Houston Lighting & Power South Texas Project Electric Generating Station P.O. Box 289 Wadsworth, Texas 77483

June 27, 1996
ST-HL-AE-5411
File No.: G20.02.01
10 CFR 50.90,
10 CFR 50.92,
10 CFR 51

South Texas Project
Units 1 & 2
Docket No. STN 50-498 and STN 50-499
Unit 1 and Unit 2 Technical Specifications 3.7.4, 3.7.14, 3/4.8.1, and 6.8.3

**SAFETY EVALUATION
AND
NO SIGNIFICANT HAZARDS
CONSIDERATION DETERMINATION**

Figure 1

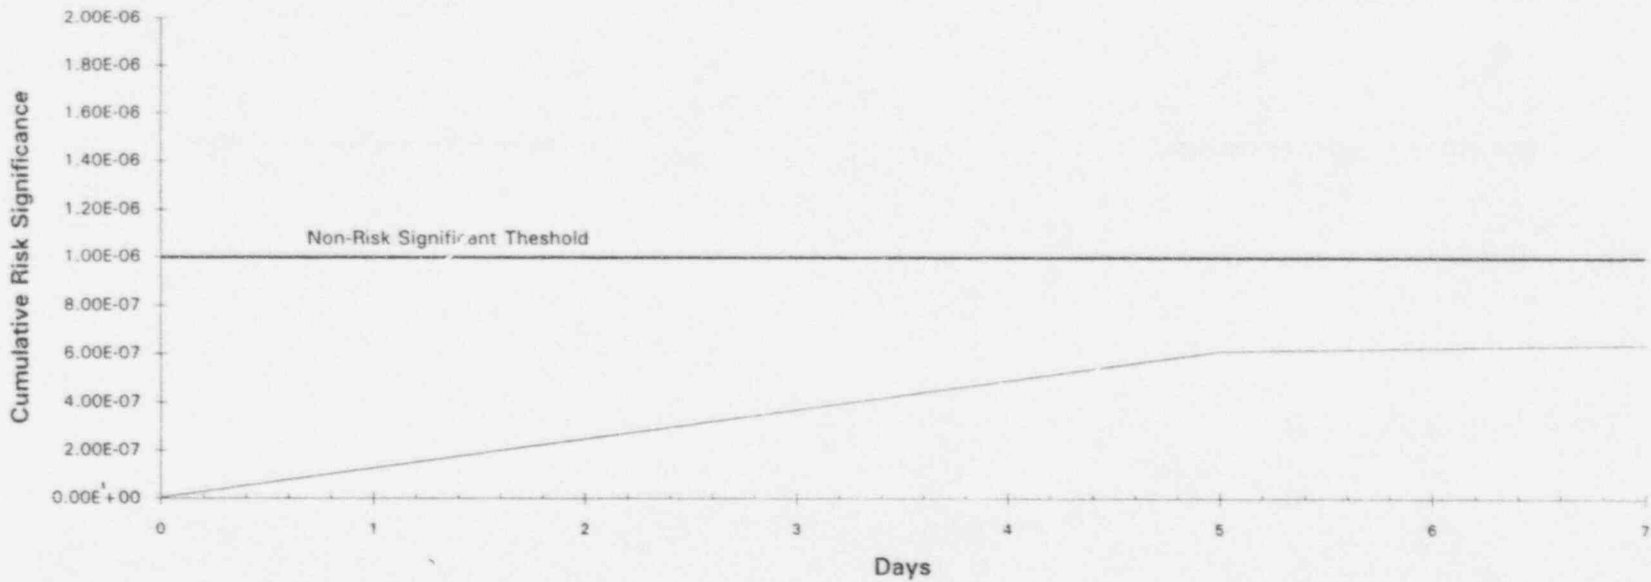
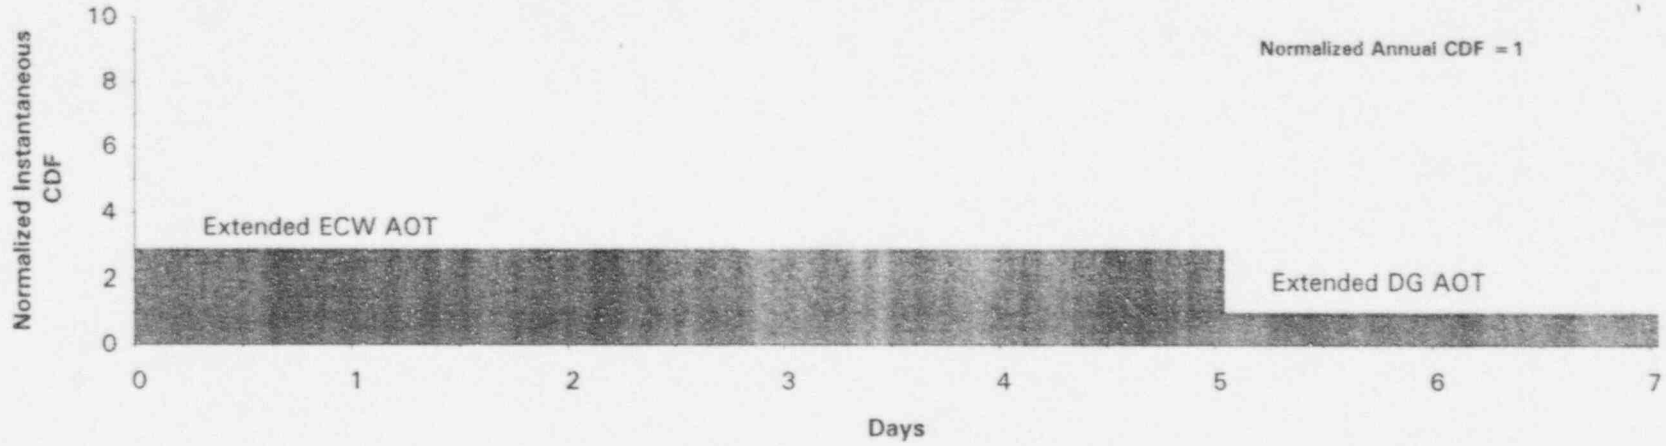
Configuration Risk Management Program would provide for appropriate compensatory measures such as those discussed in the previous submittals when necessary. The risk quantification for this application is based on the nominally expected out of service times described below. The South Texas Project plans to conduct the extended outages on a nominally once per train per cycle basis. It is expected the Diesel Generator work will take on the average 7 days to complete, while the Essential Cooling Water and any dependent system is expected to be completed within 5 days. While some of the AOTs will be less than these estimates, others will be slightly longer. Therefore, the average number of days used for completion is reasonable. The attached graph (Figure 1) represents the cumulative change in the Core Damage Probability for the extended Essential Cooling Water/Diesel Generator planned maintenance. As can be seen the cumulative change in risk does not exceed the $1E-6$ threshold established via the Configuration Risk Management Program at the South Texas Project.

The 14/7 Day Allowed Outage Times results in an average Core Damage Frequency of $2.18E-05$ per reactor year. This corresponds to 5.2% decrease in the Core Damage Frequency calculated for the previously submitted 21 Day AOT. The Large, Early Release Frequency is quantified as $4.69E-07$ per reactor year which represents a decrease of 7.5% from the value calculated for the previously submitted 21 Day AOT. The Risk Achievement Worth for one Diesel Generator during the modeled configuration is 1.02 and for one train of Essential Cooling Water during the modeled configuration is 2.9. These values are consistent with the previous 21 Day Diesel Generator STE submittal (Reference ST-HL-AE-5076).

Estimated Risk Profile for the Expected Planned Work Week given 14 Day DG & 7 Day ECW AOT
